# Modification Recommended Service Note

## P5008B Keysight Streamline Vector Network Analyzer

Serial Numbers: From MY61100009 to MY61100135

Potential lifted front panel overlay

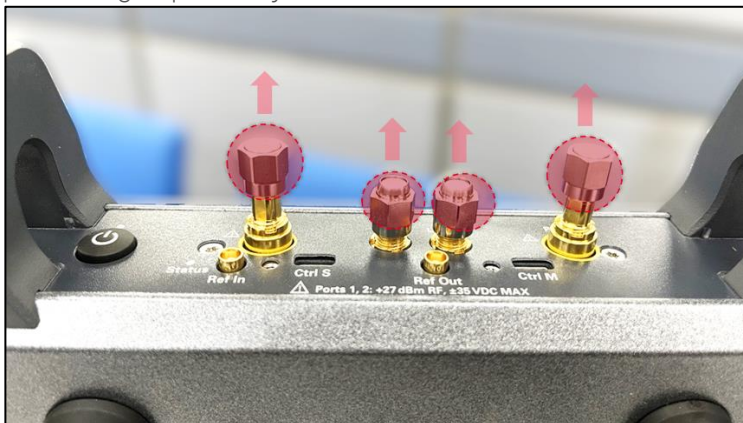
Keysight streamline series vector network analyzer (VNA) of serial number range identified in service note cover page might potentially exhibit the following lifted front panel overlay symptom.

Apart from cosmetic imperfections, the lifted front overlay could have led to non-fully attached *Ctrl S* micro-HDMI cable connector in multi-VNAs setup configuration.

-> Apply this service note only if end users' VNA is exhibiting the following symptom.

Procedure to replace the front panel overlay.

1. Remove the front handles. Detach the 50-ohm termination (LO-In, LO-Out, Port 1 & Port 2) or protecting caps if they are attached to the VNA.

2. Pry open the existing front panel overlay and remove it from front panel.
3. Clean the metal surface thoroughly and ensure it is free of adhesive residue.
4. Affix the new self-adhesive front panel overlay onto the metal surface.
5. Reinstall (reuse) the 50-ohm terminations and port protecting caps accordingly.

6. Reinstall (reuse) the front handles.
